**REZONING, PUD &
SUBDIVISION STAFF REPORT**

Date: May 19, 2005

APPLICANT NAME John F. Loupe

DEVELOPMENT NAME The Quarters at Heron Lakes

SITE PLAN

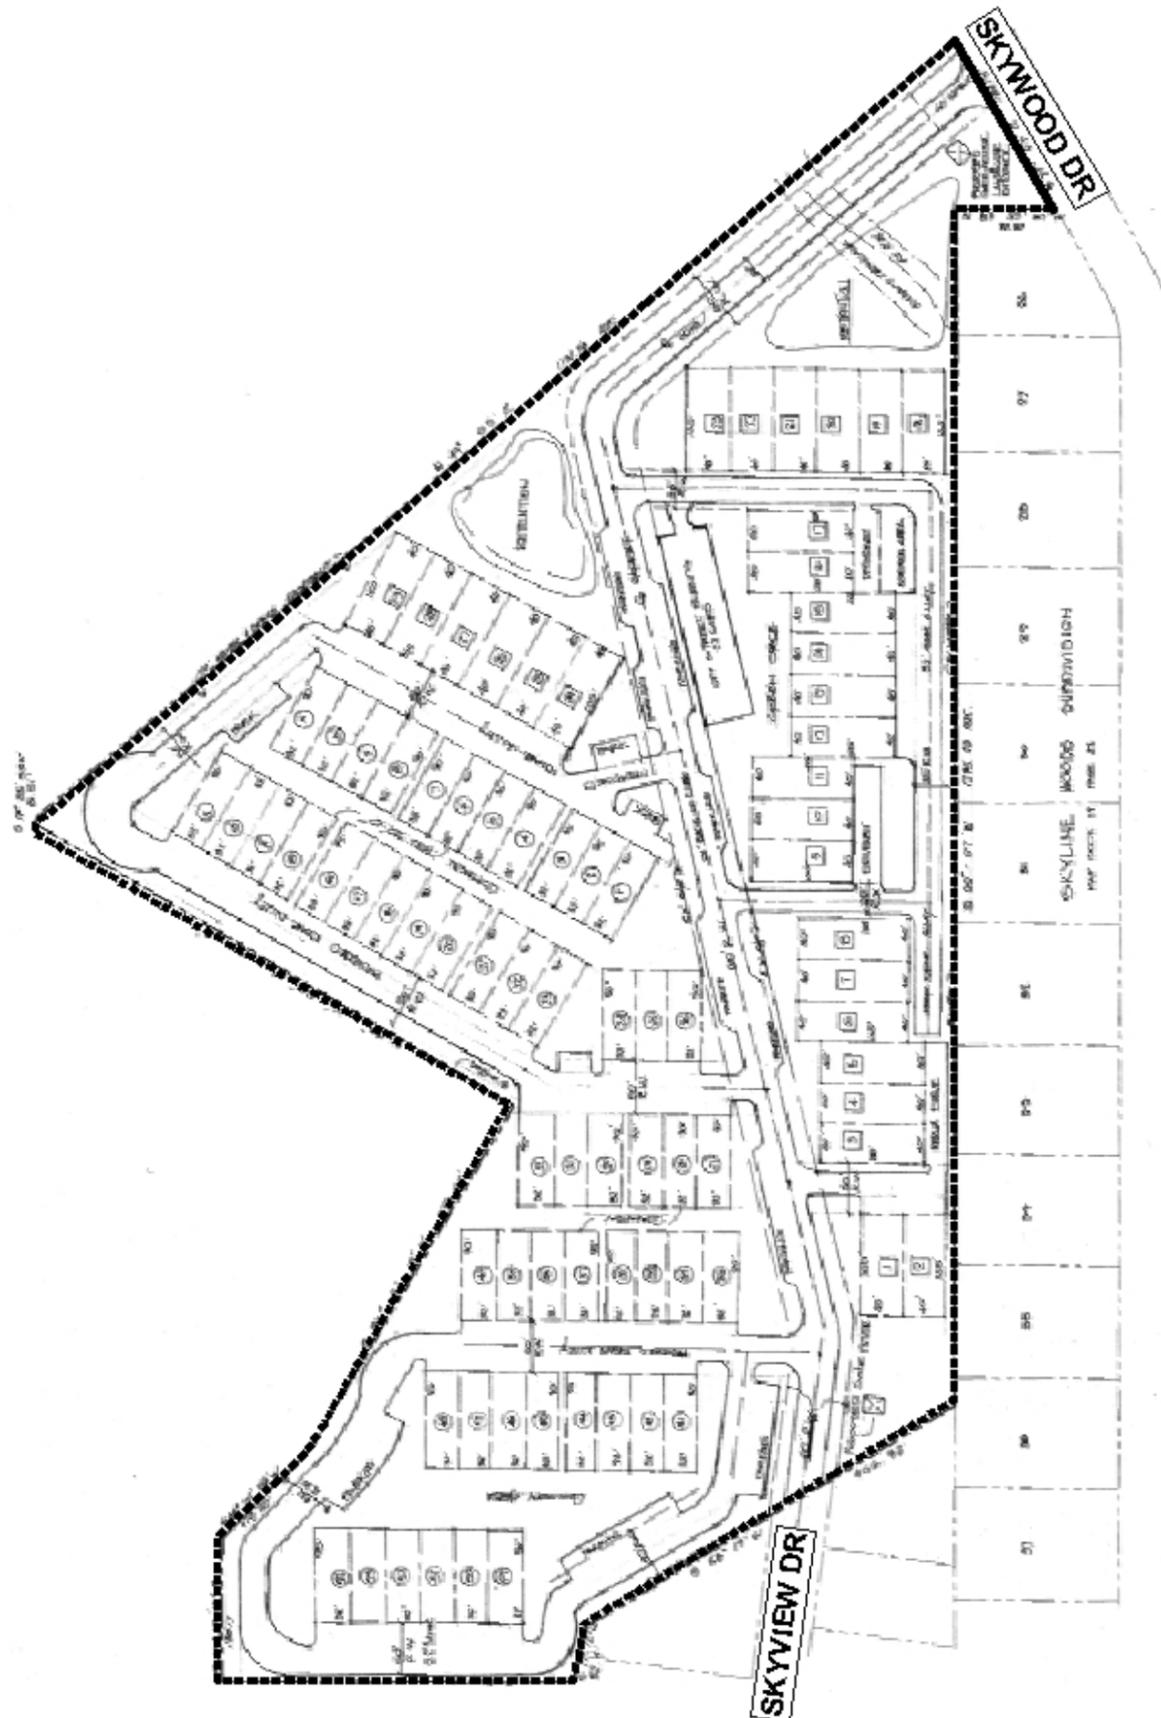
ENGINEERING COMMENTS Significant, serious drainage problems existing on site and downstream. Contours not provided by applicant therefore, thorough evaluation of all problems not available. Drainage from Burma Road and significant area north of

Govt Blvd drain through site. Applicant must accommodate all existing drainage systems through site AND ensure existing outfall systems are adequate to handle the impact of the additional discharge from this development. Must comply with all stormwater and flood control ordinances. Any work performed in the right of way will require a right of way permit.

Driveway number, size, location, and design to be approved by Traffic Engineering and conform to AASHTO standards. The addition of the projected traffic flows of this development to Skywood Drive will cause Skywood Drive to meet MUTCD warrants for the installation of a traffic signal. The installation of a signal will require geometric changes to the roadway at the intersection of Highway 90. With the additional time allotted by the holdover, the Traffic Engineering Department conducted a more detailed study of the intersection of Skywood Drive and Highway 90. Because the majority of the current traffic is right turn movements, the installation of a signal may not be necessary. However, the additional traffic may warrant geometric changes to the intersection such as turn lanes or an acceleration lane.

While this is an innovative development and appears to meet the general requirements for rezoning, PUD approval, and innovative subdivision approval, there were some minor issues relating to the application as originally submitted that have now been addressed. The applicant agreed that there would be no changes to the street or parking layout, unless required by engineering or the Fire Department; the side setbacks have been modified to a minimum of 3'-1" on one side and 6'-11" on the other for the single-family detached units; and, the Skyview Drive access has been changed to be a gated ingress and egress to accommodate Fire Department standard of two points of access for developments containing more than 29 residential units.

The revised comments from the Traffic Engineering Department indicate that signalization of Skywood Drive at Government Boulevard may not be necessary with the second point of access, but geometric changes may be needed at that intersection.

Planned Unit Development: based on the preceding, it is recommended that this application be approved subject to the following conditions: 1) completion of the rezoning and subdivision processes prior to the issuance of any permits; 2) development to be limited to the revised plan showing Ingress and Egress to be via gated access to Skywood Drive and Skyview Drive, and detached single-family dwelling side setbacks of 3' on one side and 7' on the other, and 83 lots; 3) full compliance with Engineering Department comments (Significant, serious drainage problems existing on site and downstream. Contours not provided by applicant therefore, thorough evaluation of all problems not available. Drainage from Burma Road and significant area north of Govt Blvd drain through site. Applicant must accommodate all existing drainage systems through site AND ensure existing outfall systems are adequate to handle the impact of the additional discharge from this development. Must comply with all stormwater and flood control ordinances. Any work performed in the right of way will require a right of way permit.); 4) full compliance Urban Forestry Comments - for the overall development (Property to be brought into full compliance with landscape and tree requirements of the zoning ordinance. Property to be developed in compliance with state and local laws that pertain to tree preservation and protection on both city and private properties [City Code Chapters 57 and 64 and State Act 61-929]); 5) submission of a revised drawing to reflect access and setback changes (for file copy); and 6) full compliance with all municipal codes and ordinances.

Subdivision: based on the preceding, it is recommended that the subdivision be considered under Section VIII as an innovative subdivision to allow the gated, private street and alleys, reduced lot sizes (Section V.D.2), and be granted Tentative Approval for 83 lots, subject to the following conditions: 1) compliance with Section VIII.E.2 of the Subdivision Regulations for private streets (minimum standard); 2) gates to remain functional (the gate to remain operational and in use, if gate ceases to be used, the street must be brought into compliance with city standards and dedicated to the city); 3) full compliance with Engineering Department comments (Significant, serious drainage problems existing on site and downstream. Contours not provided by applicant therefore, thorough evaluation of all problems not available. Drainage from Burma Road and significant area north of Govt Blvd drain through site. Applicant must accommodate all existing drainage systems through site AND ensure existing outfall systems are adequate to handle the impact of the additional discharge from this development. Must comply with all stormwater and flood control ordinances. Any work performed in the right of way will require a right of way permit.); 4) all areas not designated as placement of a note on the final plat stating that maintenance of all common areas and detention facilities shall be the responsibility of the property owners; 5) completion of the rezoning process prior to the issuance of any permits; and 6) placement of a note on the final plat stating that development limited the accompanying (amended) PUD.
